DOCUMENT CHANGE REQUEST

DCR number 489 Changes required for: General

Title: Transistors Low Power NPN, based on type 2N3700

Number: 5201/004 Issue: 3

1.6.1 Metal Can Package (TO-18) - 3 lead

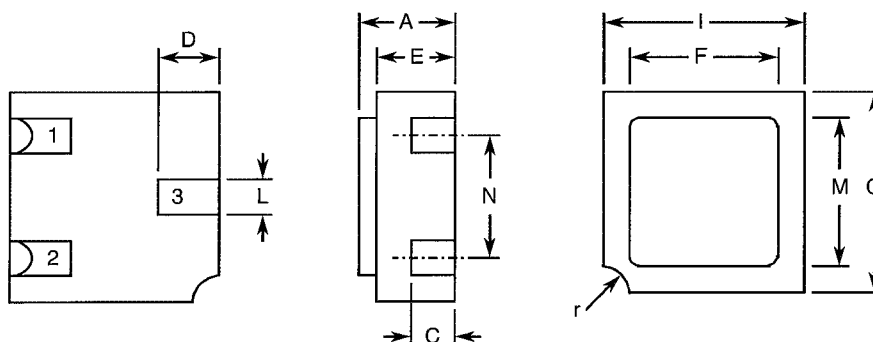
Note
addition of
horizontal
lines

1.6.2 Chip Carrier Package (CCP) - 3 terminal

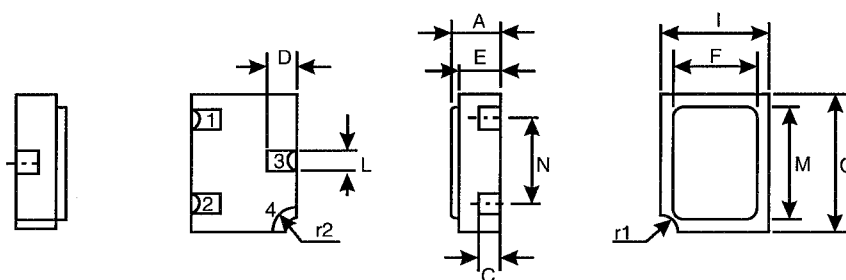
Note
addition of
horizontal
lines
